## PLANNING COMMISSION STAFF REPORT

**SUBJECT:** Planning and Zoning Permit No. 06-400-5 (Coastal Development Permit) for Southern California Edison (SCE) Peaker Plant Located at 251 N. Harbor Boulevard

**SCE LETTER OF APRIL 19, 2007**

**Subject: Coastal Development Permit PZ 06-400-5, Proposed SCE Peaker Plant, 251 N. Harbor Blvd., Request for Additional Environmental Analysis for the Mitigated Negative Declaration**

AA SECTION-ELEVATION THROUGH SITE FROM NEIGHBORING DEVELOPMENT  
SCALE 1"=40ft.

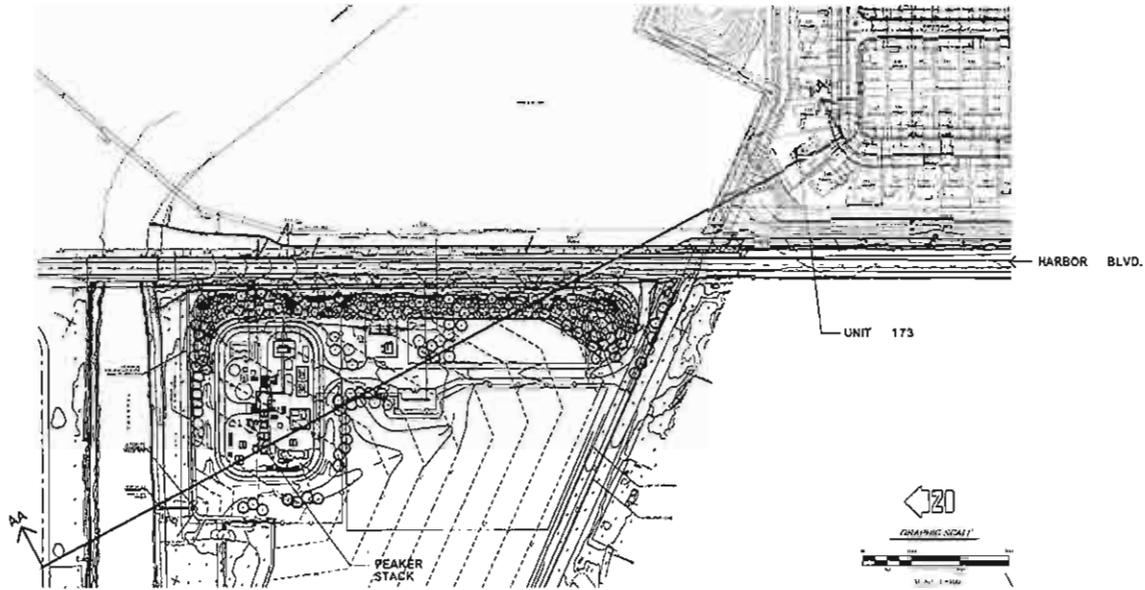
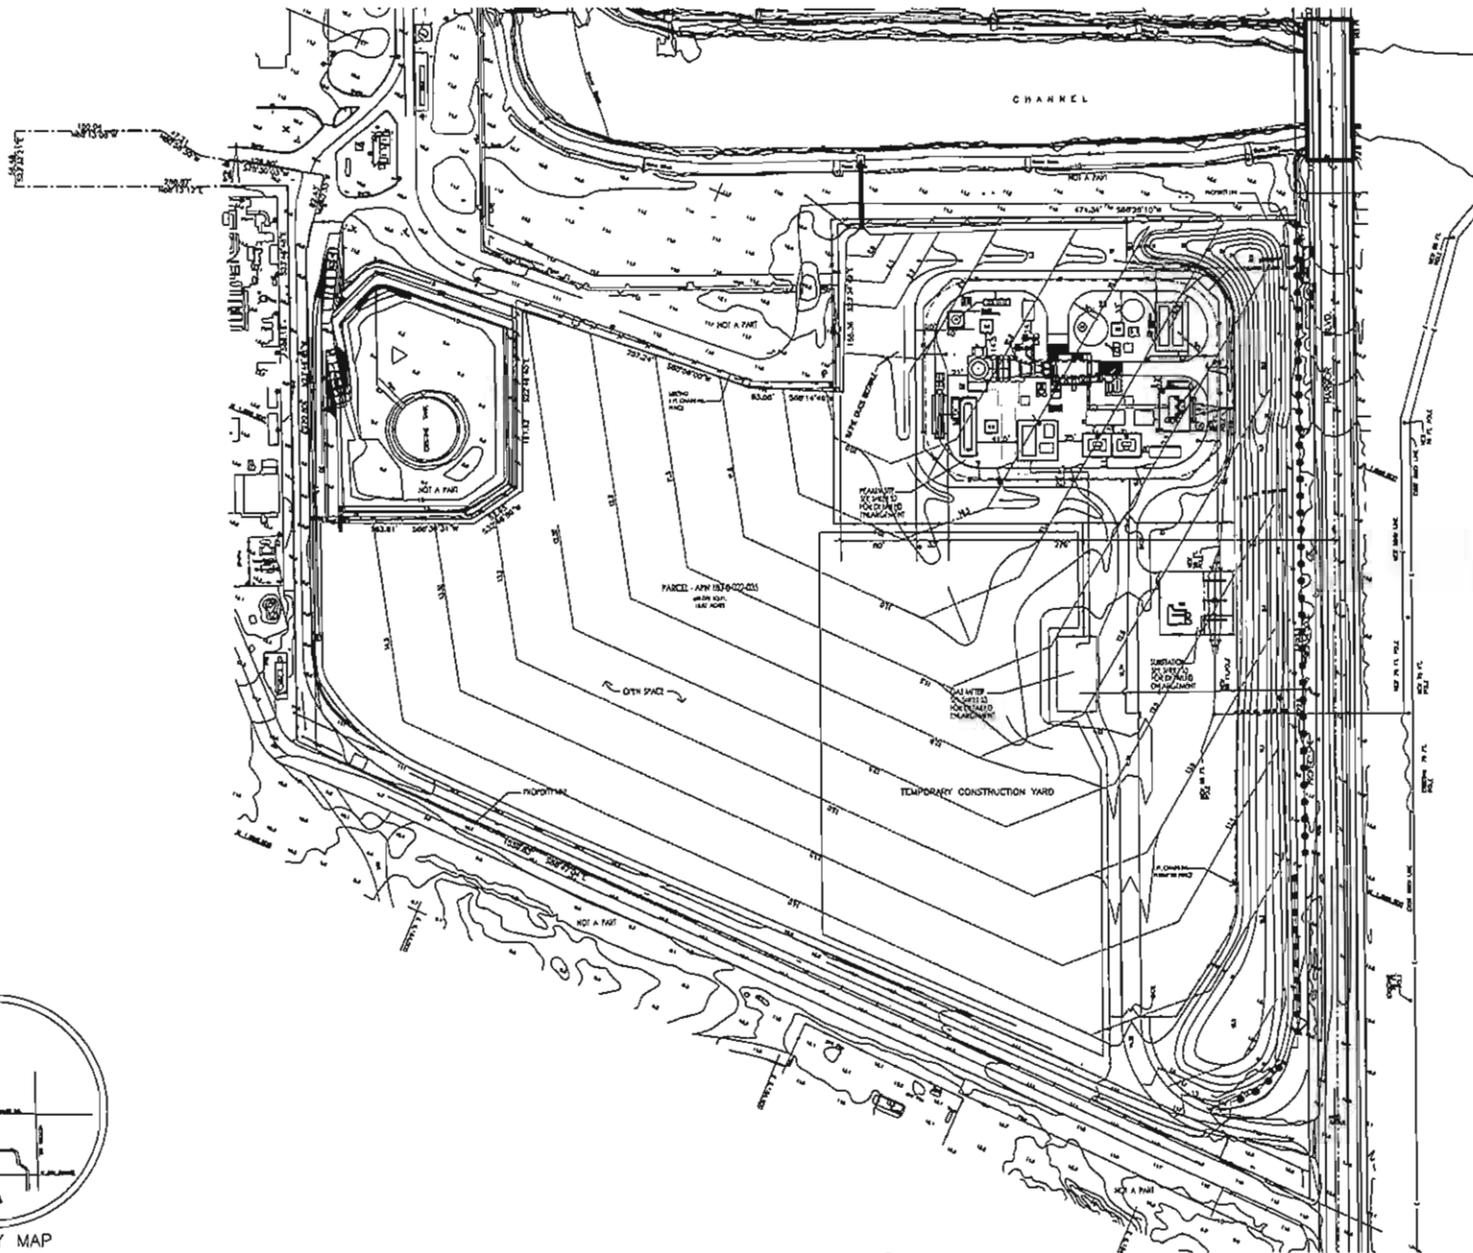
"The Northshore housing project, located just southeast of the project site, will have elevated building pads of up to 20 feet above Harbor Blvd. The MND needs to include an elevation cross-section from Northshore to the west lot line of the peaker plant to determine the line of site from the second floor windows of Northshore homes located opposite the peaker plant. Mitigations are needed to block the view from these windows. Northshore engineering, grading, and building plans are available from Linda Windsor, 805-385-7849."

Jordan, Gilbert & Brown reviewed information provided from both Linda Windsor and Bill Teller from the Northshore project regarding grading and building plans in order to prepare the requested elevation cross section from the second story window of the nearest home. In addition, SCE created a computer simulation of the view from this home. Both views show that the tree species used in the proposed landscape plan will, at full maturity, fully shield the facility from the Northshore development's second story windows as requested, with the exception of the stack and the transmission poles which are not able to be shielded. We expect that within 3-5 years after planting, the growth rate would be such that the majority of the facility would be fully screened.

The requested views have been incorporated into the MND.
